Temporary Logistics Centre with Ancillary Facilities and Associated Filling of Land for a Period of 3 Years
at
Lot 403 RP (Part) in D.D. 103 and Adjoining Government Land, Kam Tin, Yuen Long, New Territories

TPB Ref.: A/YL-KTS/1154

Response to DSD's comments - Proposed Temporary Logistics Centre for a Period of 3 Years and Filling of Land in "Argriculture" Zone, Lot 403 RP (Part) in D.D. 103 and Adjoining Government Land, Kam Tin, Yuen Long, New Territories (Application No. A/YL-KTS/993)

Figure 4

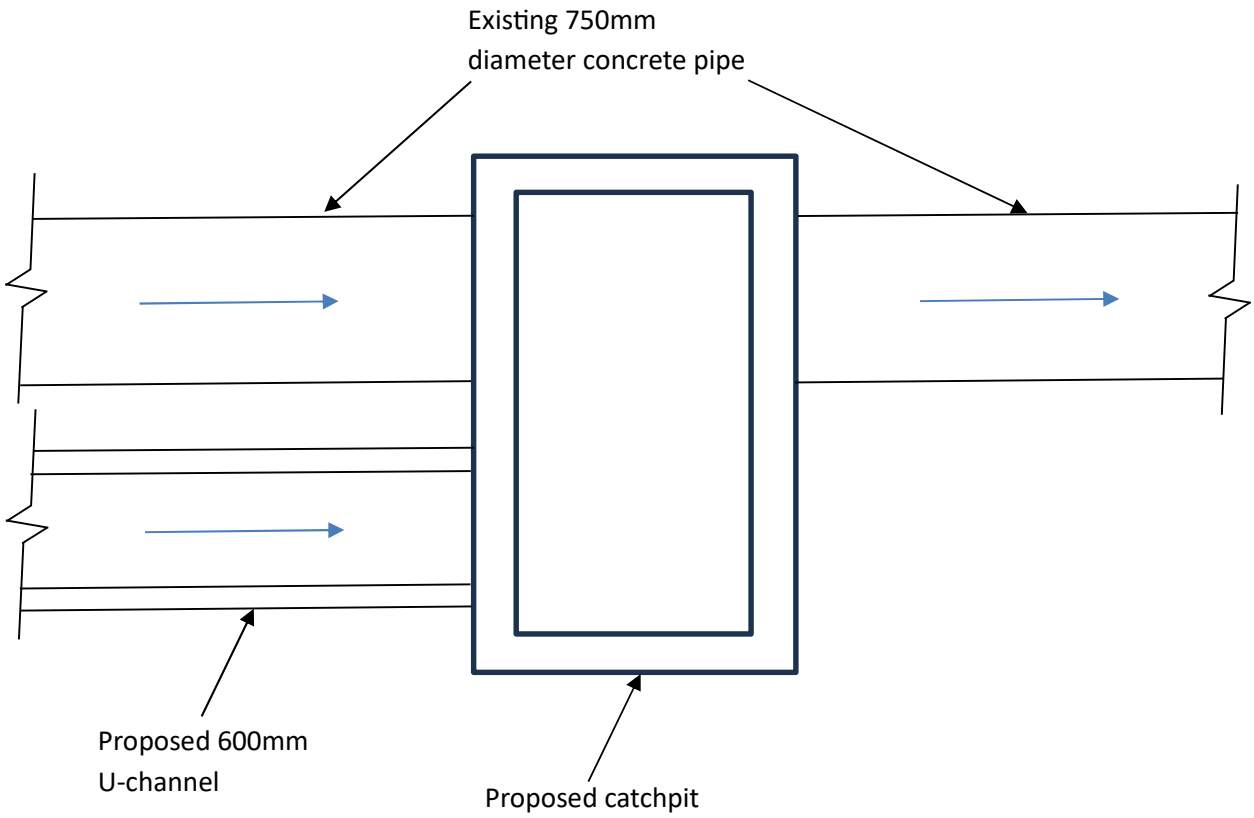
(a) Please indicate the existing opening drain and the discharge path on photo 1 & 2. Please also indicate the photo taken directions on drawing.	please see the updated Figure 4.

(b) Please show the size of the existing drainage facilities, i.e. the aforementioned existing opening drain and the discharge path, on drawings.	please see the updated Figure 4.

(e) The velocities of stormwater flow in channels should be checked and given in the submission.	please see the enclosed design chart which shown the revised gradient is 1 : 55 and the velocites of stormwater flow in channel is around 3.9m/s.
Please specifiy the distance between the proposed gaps and the height of the 100mm gaps in figure 4.	please see the updated Figure 4.

Figure 5 - Catchpit (SCP)

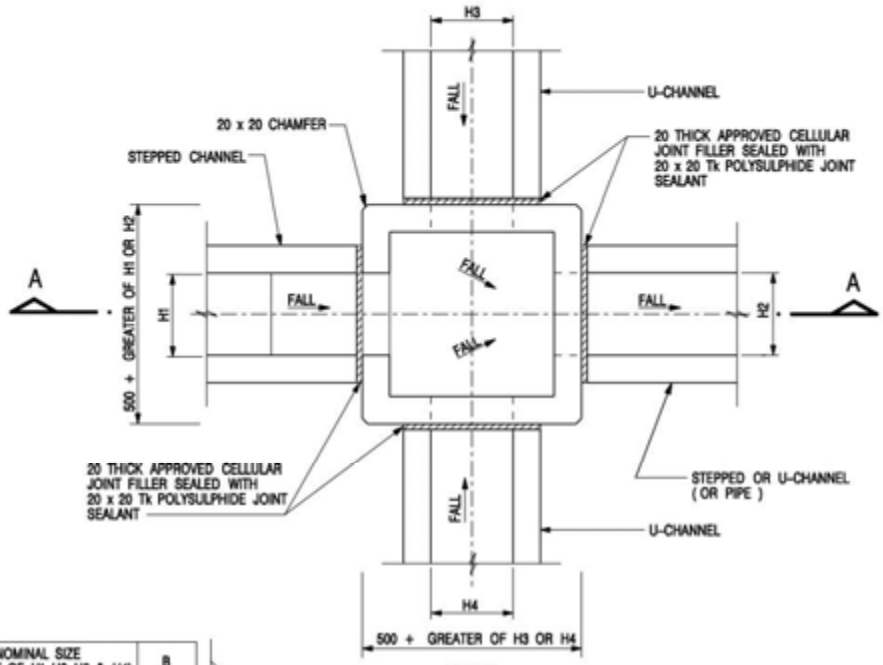
(c) Connection details of the proposed channel at the proposed channel at the proposed discharge point at river should be given.	please see the enclosed Figure 5.

FIGURE 6

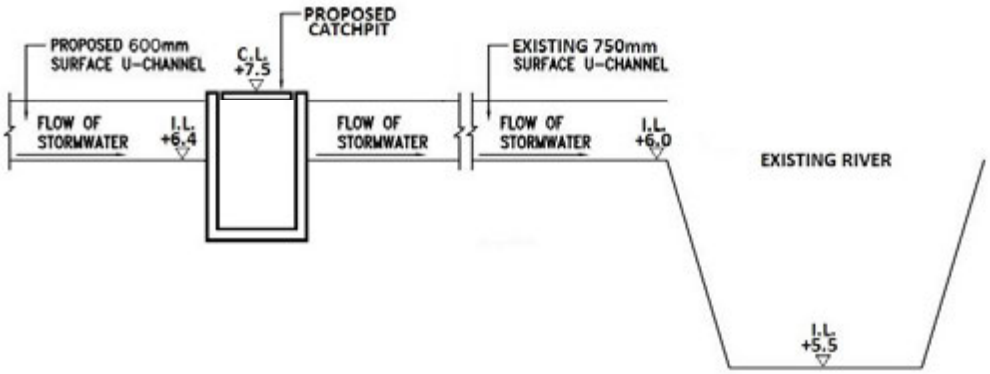
(i) The connection details (figure 6) submitted is not tally with the details showed in figure 5 below. Please clarify. Please also show the C.L., I.L. and G.L. of the existing/proposed pipe/channel and existing river in figure 6.	please see the revised Figure 6.
